RESPONSE TO:

TECHNICAL REVIEW OF AQUILA RESOURCES'  
BACK FORTY MINE PERMIT AMENDMENT APPLICATION  
CENTER FOR SCIENCE IN PUBLIC PARTICIPATION (CSP2)  
FEBRUARY 11TH, 2019

AQUILA RESOURCES INC.  
STEPHENSON, MICHIGAN

**Graph 4: TMF Total Post-Closure Leachate Generation Rate with Time**

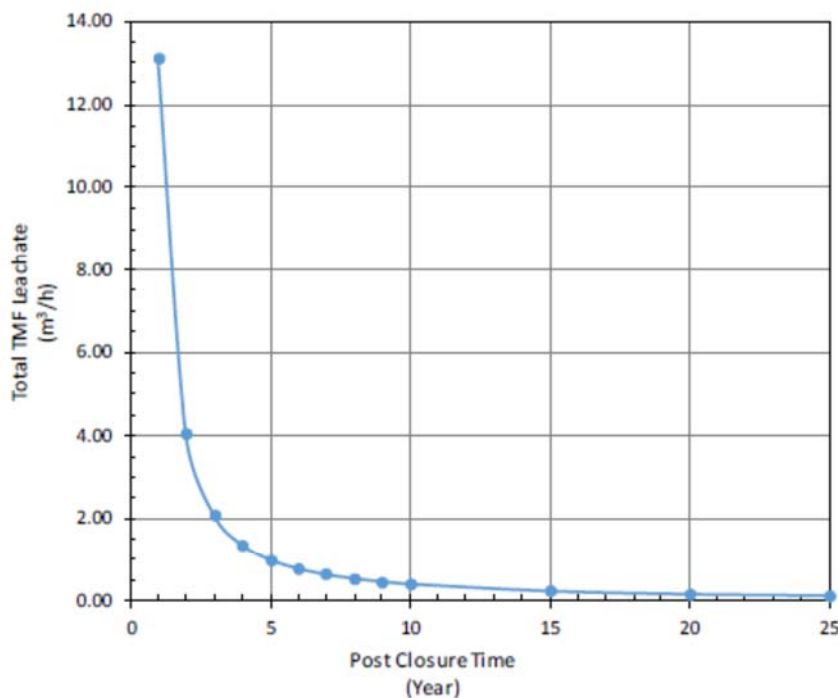
The spreadsheet cost estimates for post-closure water treatment are approximately \$1 million for capital investment, and \$2.6 million for 10 years of operation. Unfortunately,

there is no way to predict that treatment can be terminated after 10 years; 10 years is at best a guestimate.

- In order to protect the public, the financial surety should cover treatment in perpetuity. Then, when flow actually stabilizes, the amount can be adjusted and monies returned to the company.

The \$2.6M allowance for postclosure water treatment was based on the water treatment unit cost in the project cost model and conservatively addresses the treatment costs for average annual postclosure TMF seepage rates predicted in Section 11.4.2 in Appendix C of the MPAA. The costs to treat the final major flux of water during the first year of Phase 3 reclamation is estimated to be \$422,000. As seepage subsides in Year 2 and Year 3 of Phase 3 reclamation, the annual water treatment costs decrease to \$140,000 and \$56,000, respectively. In summary, the \$2.6 allowance for postclosure water treatment in the financial assurance cost estimate for the LOM operation period accounts for the treatment of the final major flux of water from the TMF and CWB at the onset of Phase 3 of reclamation and 25 years of postclosure water treatment. This includes operation of the Closure WWTP following decommissioning of the Operations WWTP.

(Left) MPAA  
Figure 2-2  
“Project site  
development  
plan”. (Below)  
Golder 2018  
Figure 12 in  
the Dam  
Safety Permit  
Application.

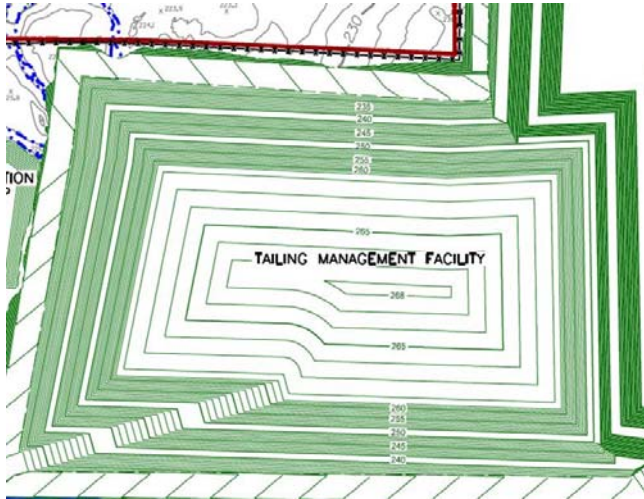
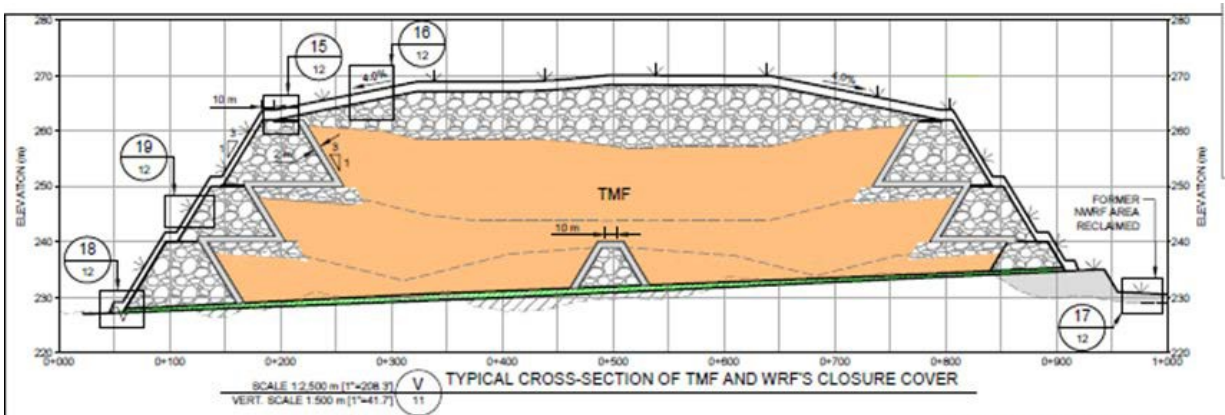
The images of the operational TMF in the **MPAA Figure 2-2** show increasing elevation to the very top of the TMF. This would not seem to be feasible given the approximately 35% moisture content of tailings.

It is also inconsistent with the diagrams throughout the **Dam Safety Permit Application**, such as Golder 2018, Figure 12 shown earlier in this memo. If **Figure 2-2** shows the TMF closure design, that should be clearly stated. Additionally, there are several references to the TMF dams as “perimeter berms”. These are massive structures requiring a Dam Safety Permit, and as such should be consistently designated as dams throughout the MPAA. Additionally, there appears to be an inconsistency between the **Dam Safety Application 1L**

**Table 2 and the MPAA.** The MPAA has the TMF at 124 acres and 138-feet high, while the dam application has the TMF as 124 acres and 118-feet high.

- TMF designs need to be consistent.

Figure 2-2 of the MPAA illustrates the facility at full buildout. This depiction shows the full facility footprint, with each structure at its maximum extent. The figure is not intended to show a closure design, hence that term is not used on the figure. Figure 2-2 is also not intended to show an operational TMF. Full buildout of all structures will not occur at the same time.

The TMF design with various stages, design details, and operational discussion are provided in the MPAA Appendix C. This appendix should be reviewed to address any concerns regarding the feasibility of storing tailings. Interpreting Figure 2-2 as a summary of the information in that Appendix C would be inappropriate.

Responses under comment 02 above discuss the TMF design. Perimeter berms constructed from waste rock provide structure to store the dewatered tailings. The TMF is not a traditional dam, however, it is a dam according to the Michigan definition described under NREPA Part 315. A dam safety permit application has been submitted.
